BOARD ACTION REPORT – APPEALABLE ITEM

Project Name:	8 East Atlantic Avenue
Project Location:	8 East Atlantic Avenue, Old School Square Historic District
Request:	Class II Site Plan Modification, Landscape Plan, Elevations and Certificate of Appropriateness
Board:	Historic Preservation Board
Meeting Date:	April 4, 2018

STAFF REPORT

ITEM: 8 East Atlantic Avenue, Old School Square Historic Arts District – Class II Site Plan Modification, Landscape Plan, Elevations and Certificate of Appropriateness (2018-042) for alterations to the front façade and improvements to the exterior dining area.

1	PROPOSED OVERALL SITE PLAN
A-101	1" = 10'-0"

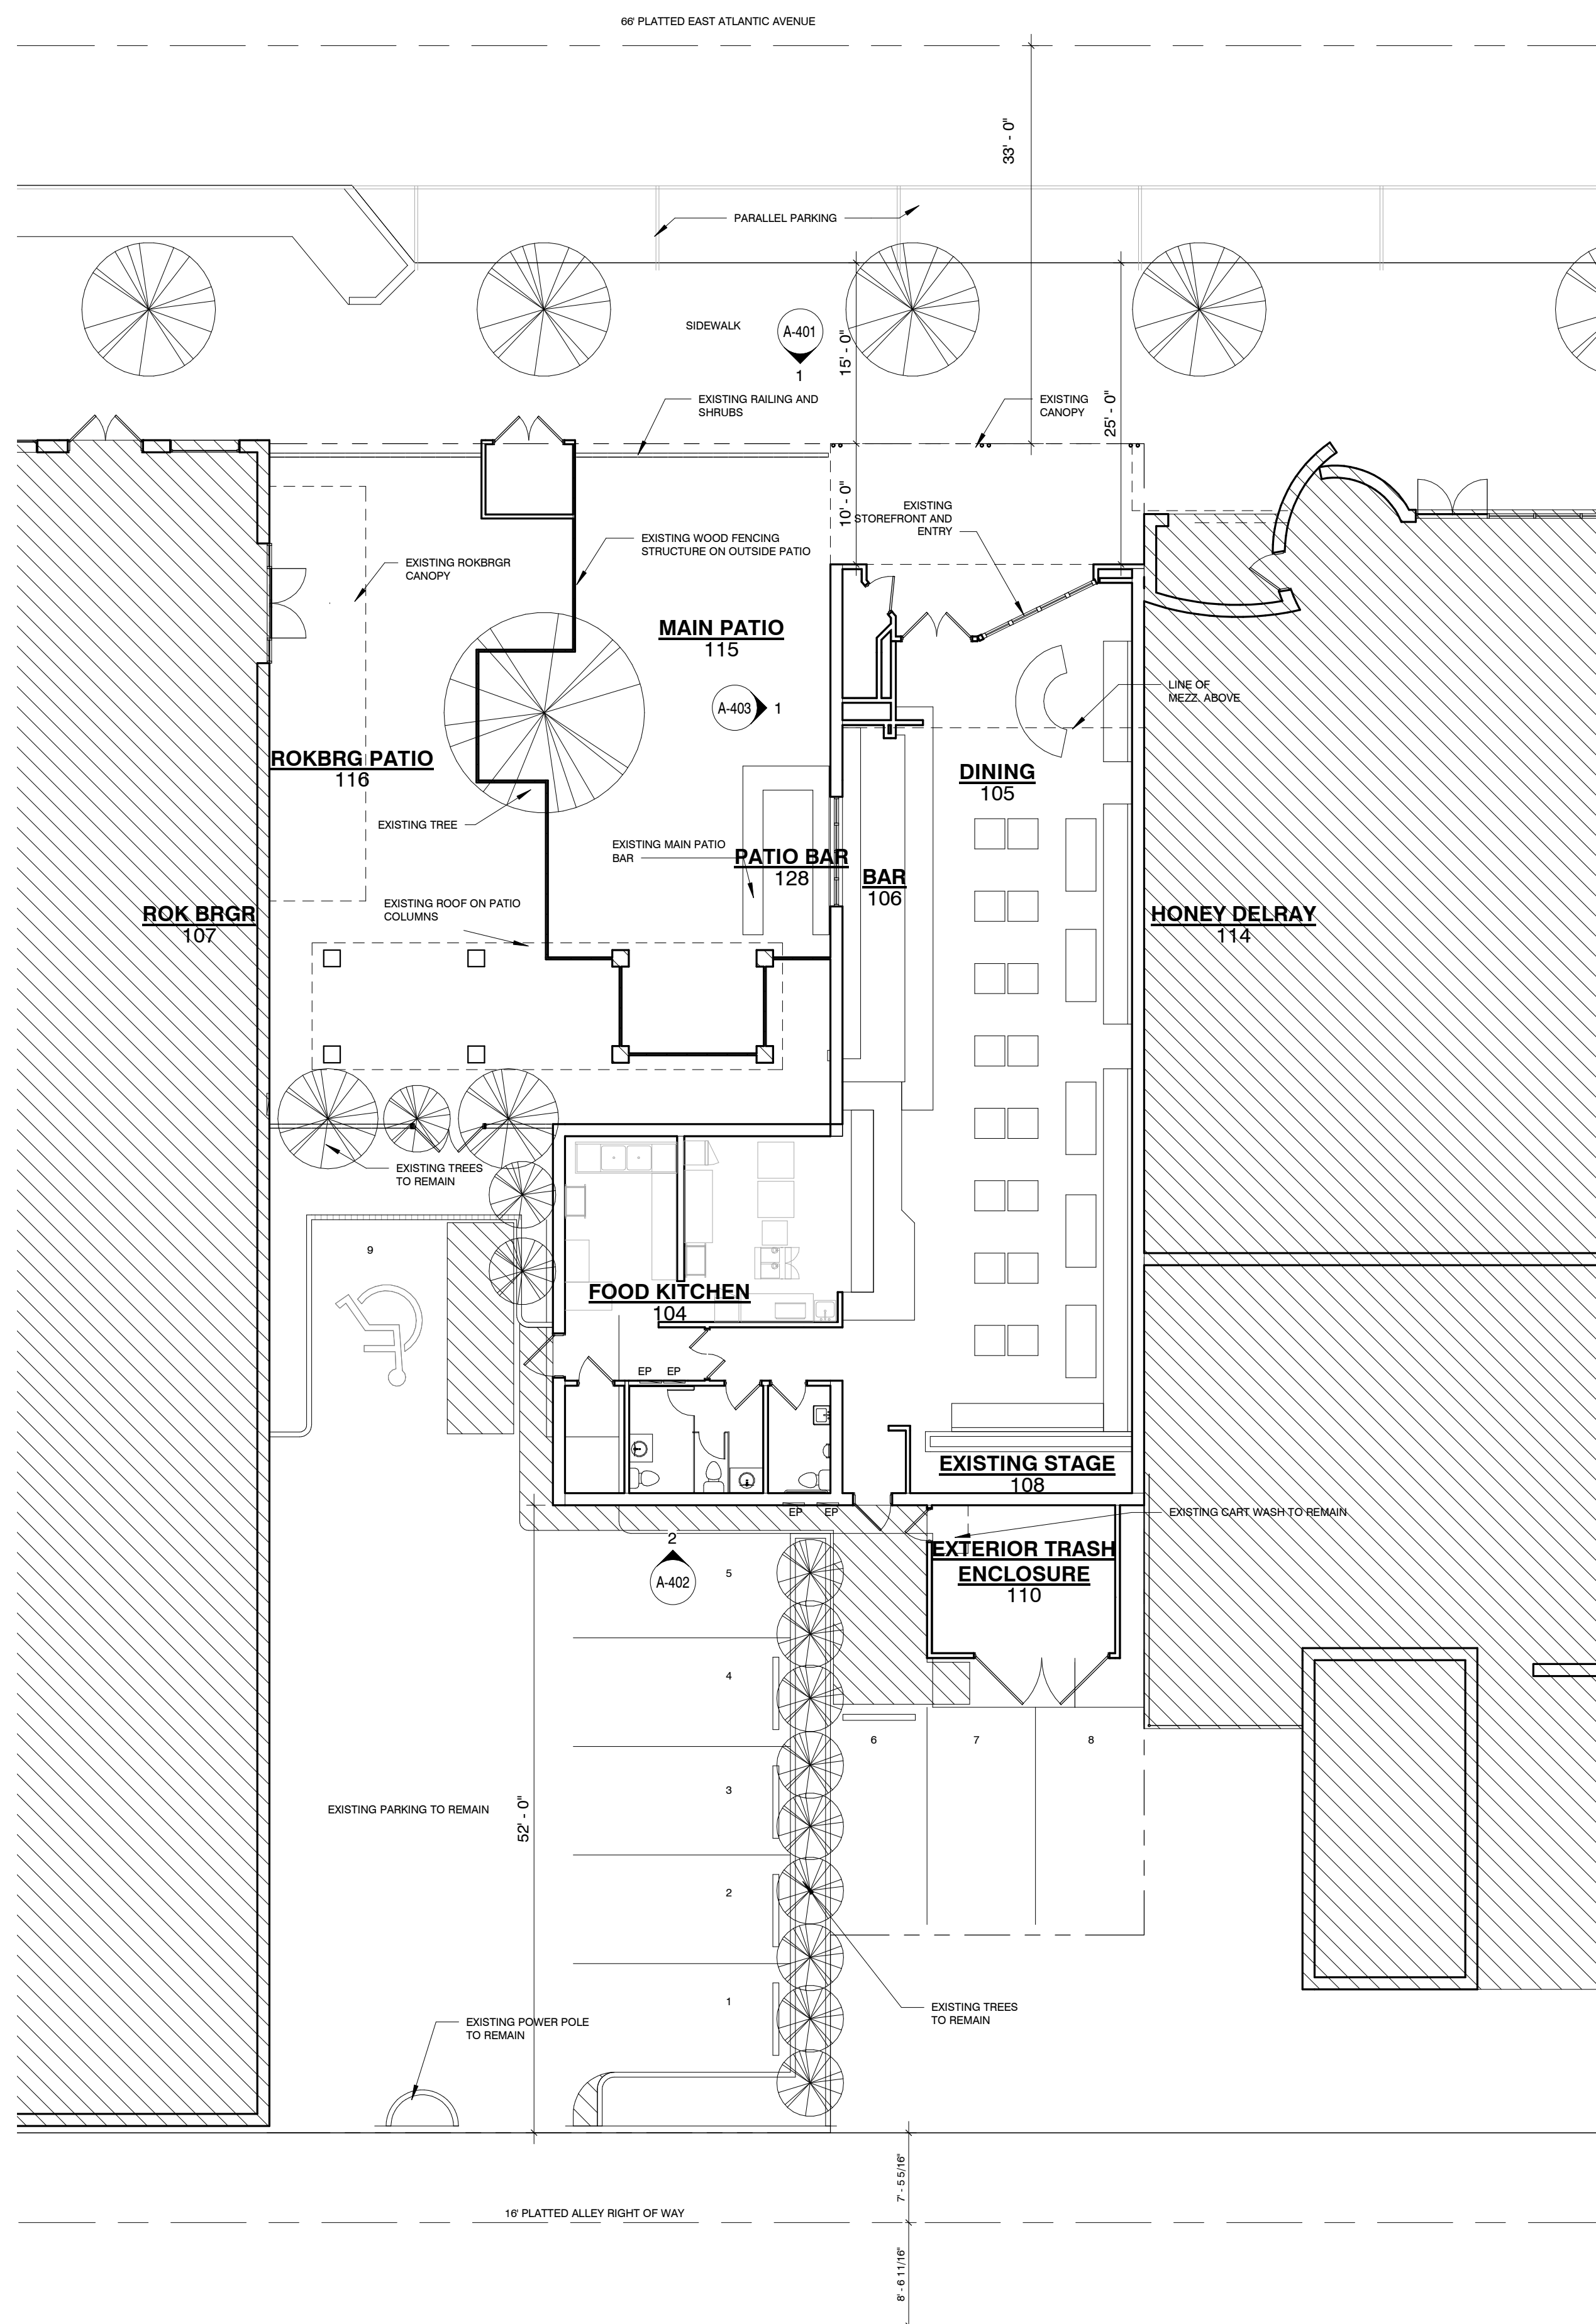
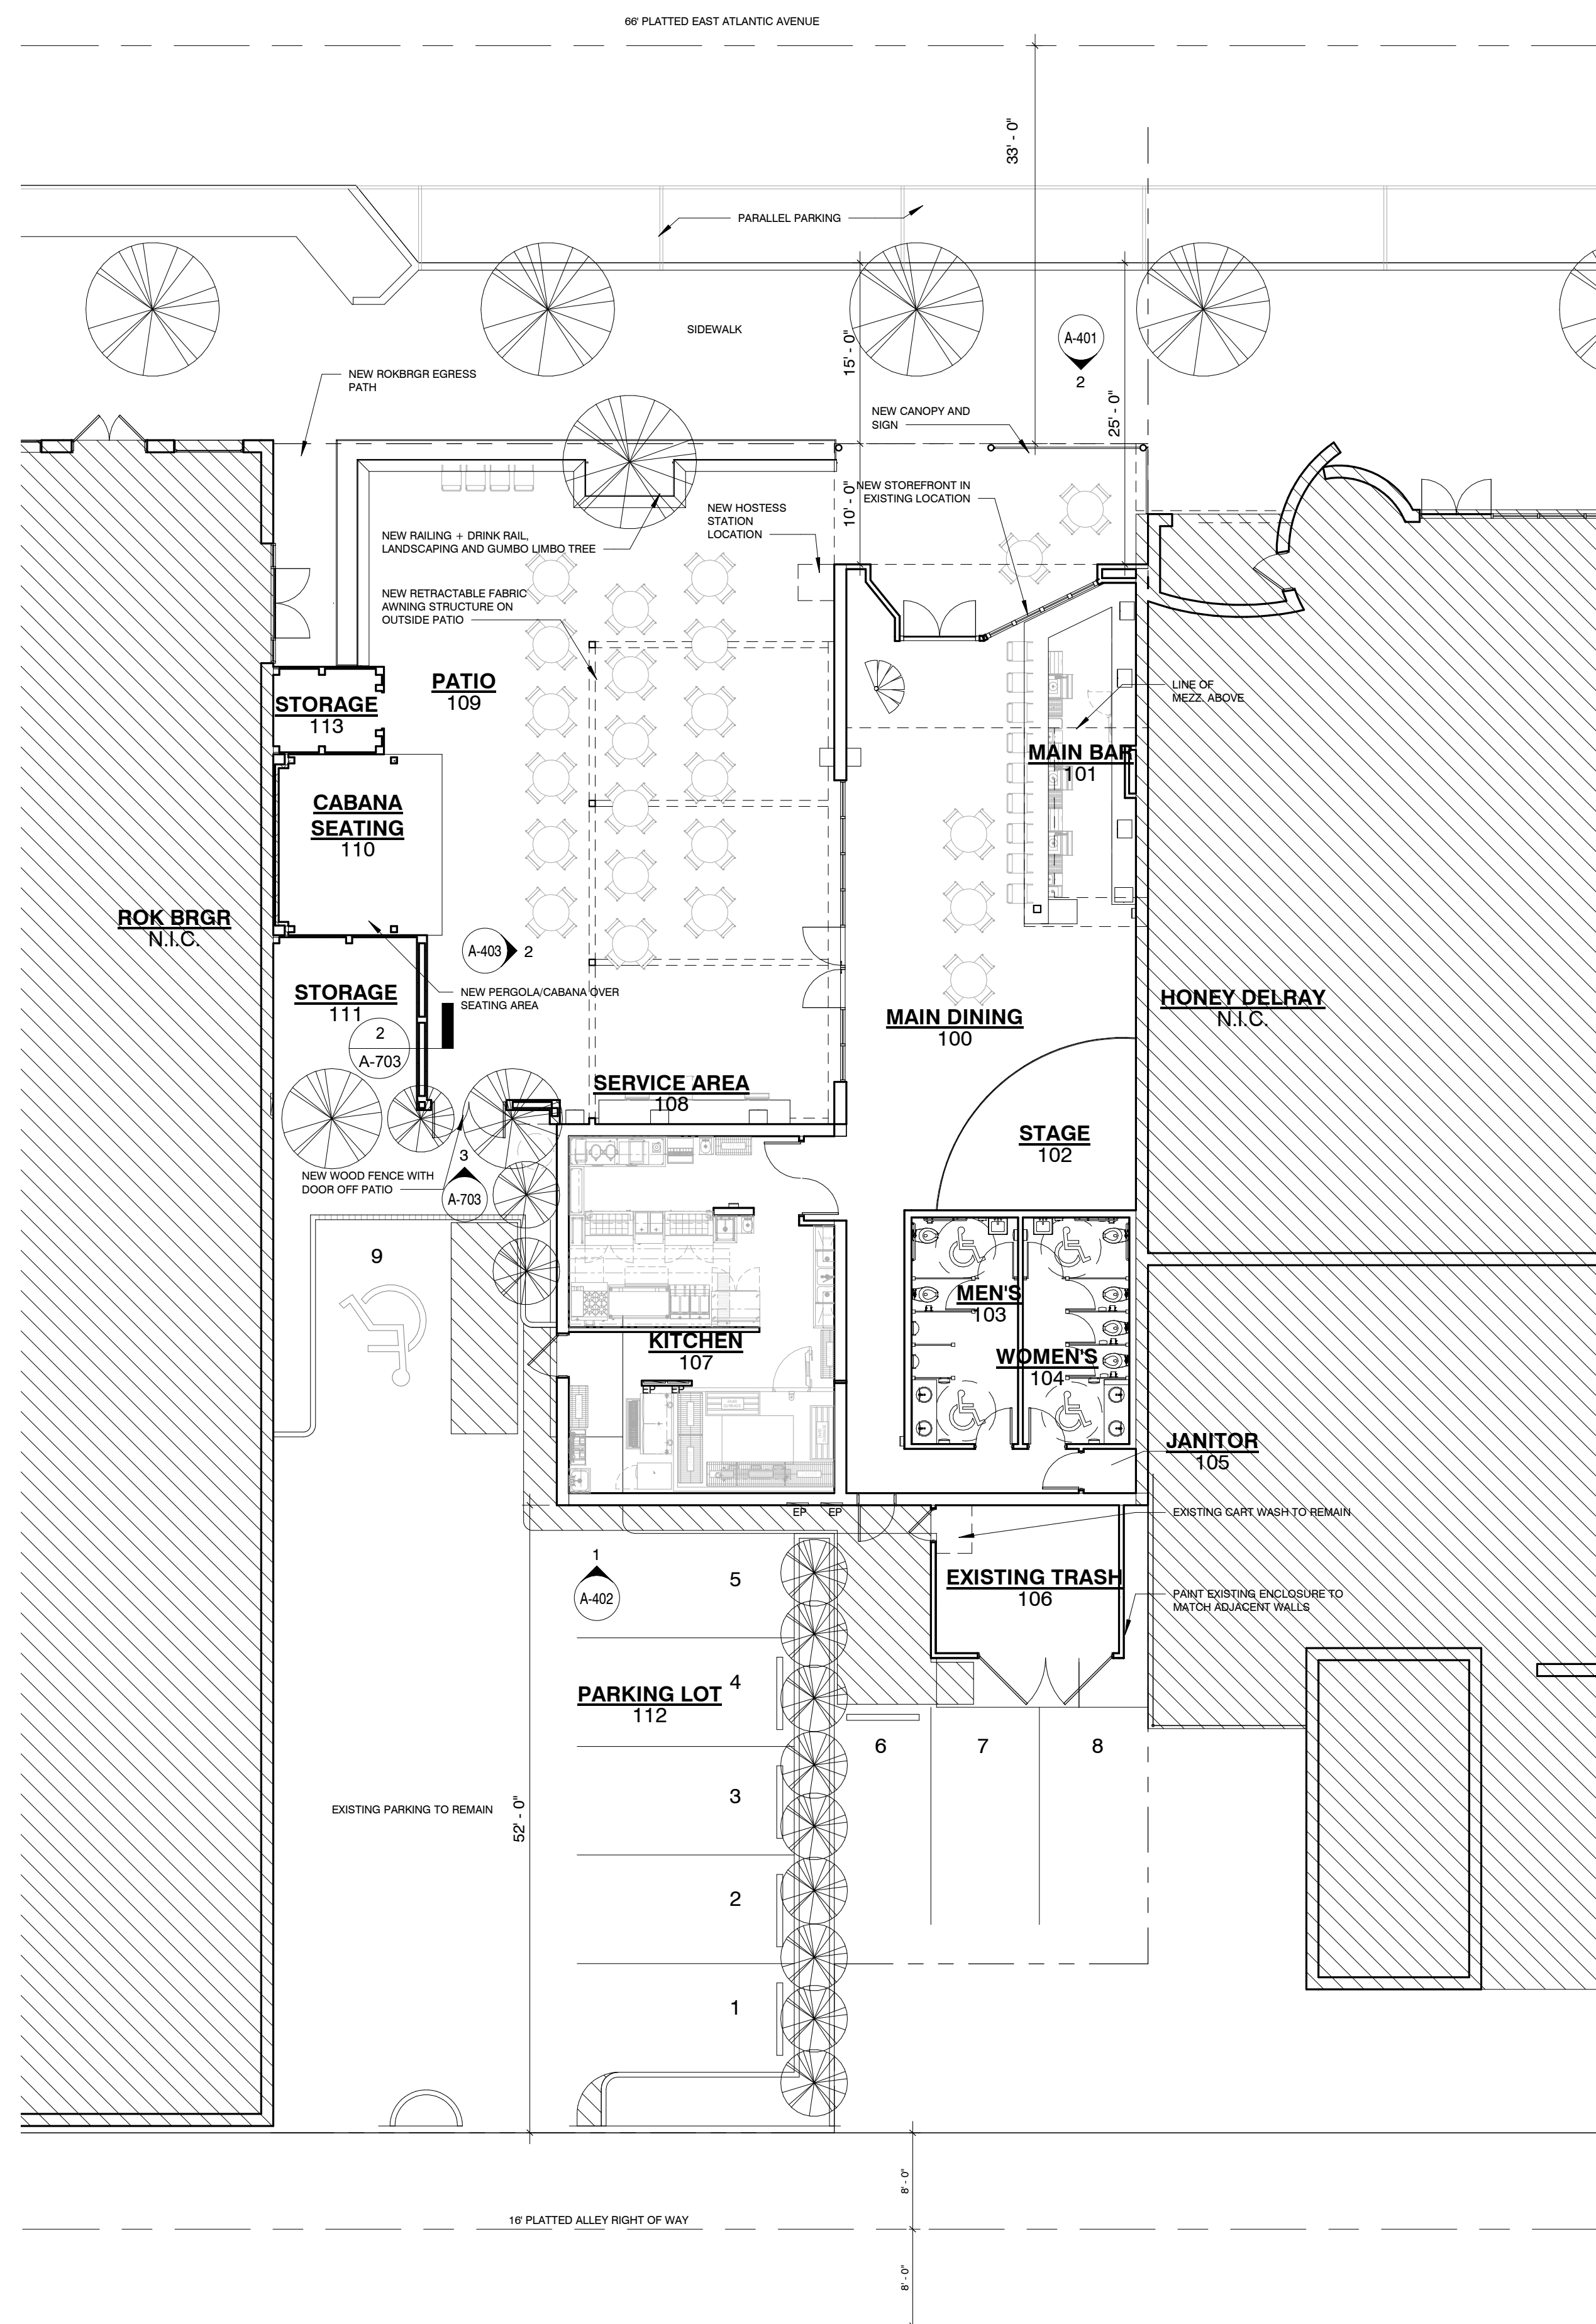
One member of the public asked for clarification on where the new horizontal aluminum railing was proposed.

1. That the site data table be revised to show the required building height maximum and include the number of seats that is proposed.
2. That the center line dimensions of East Atlantic Avenue be revised to show the same measurement on the existing and proposed site plan.
3. That the elevations include height dimensions for the new pergola and outdoor storage areas.
4. That the elevations indicate the material of the new cabana;
5. That the new roof top units be relocated 10 feet from the roof edge, or guardrail/shielding be installed.

1. That the site data table be revised to show the required building height maximum and include the number of seats that is proposed;
2. That the center line dimensions of East Atlantic Avenue be revised to show the same measurement on the existing and proposed site plan;
3. That the elevations include height dimensions for the new pergola and outdoor storage areas;
4. That the elevations indicate the material of the new cabana; and,
5. That the new roof top units be relocated 10 feet from the roof edge, or guardrail/shielding be installed.
